**City of Portland, Maine - Building or Use Permit Application**

Proposed Project Description:  
Roof top deck w/access only to 3rd floor Condo tenant

RE: Rooftop Deck Addition Structural Feasibility Review, 77 Vesper Street, Portland, ME

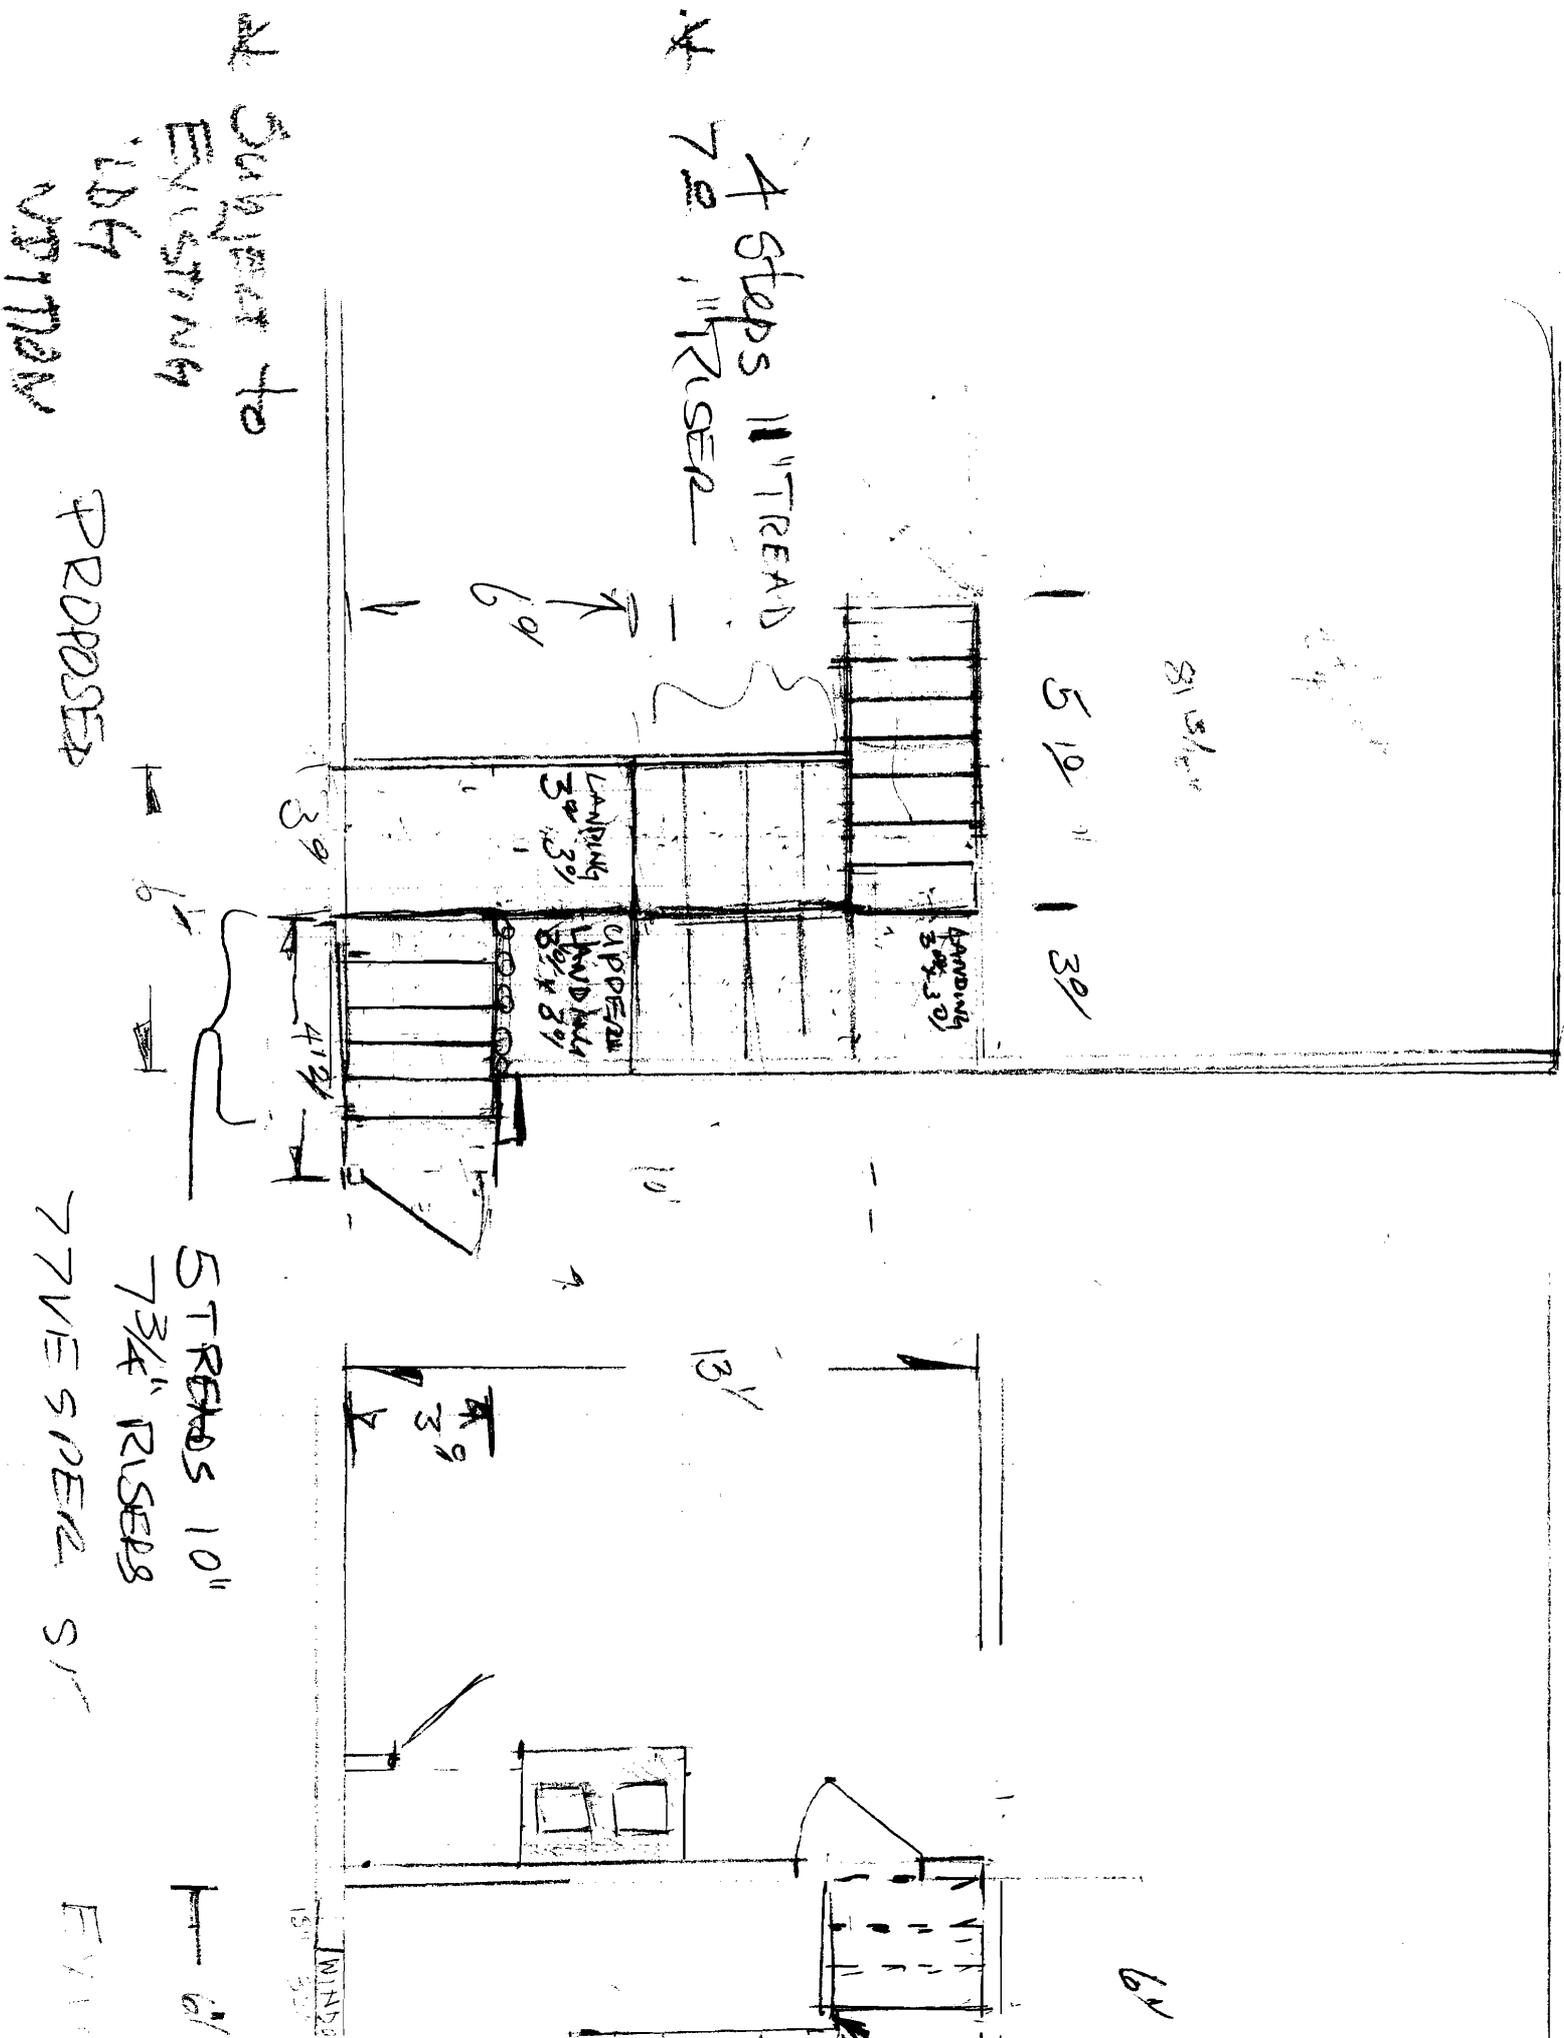
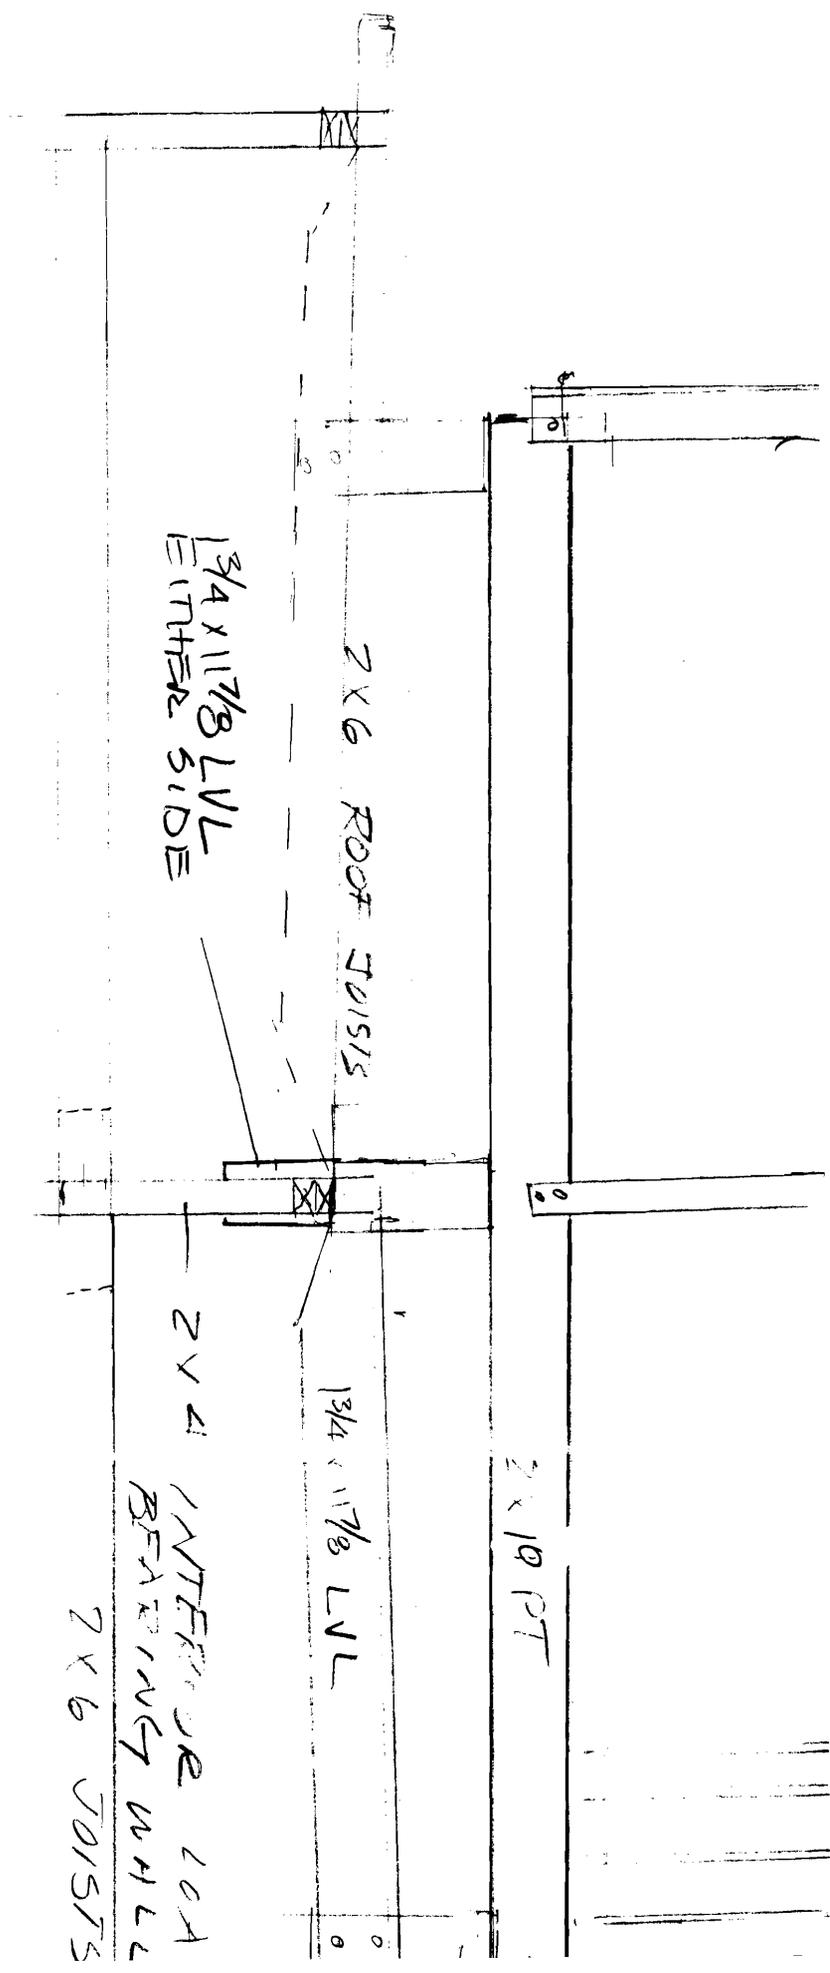
10/26/2007-mes: called Tom B. to get me an elevation of the building to show that it is under the 45' max. height - he will get that to me.

Tom,  
This is very helpful. But can I get a quick drawing too.  
Marge

10/29/2007-mes: Tom B. dropped off a sketch of the building height.

>>> "Thomas Blackburn" <teblkbrn@maine.rr.com> 10/26/2007 3:32:22 PM >>>  
Marge, The height to the top of the roof deck is 34 feet 1 inch. The height of the tallest point in the roof (the roof access structure) from the ground is 40 feet 3 inches. If you require any more information please advise.
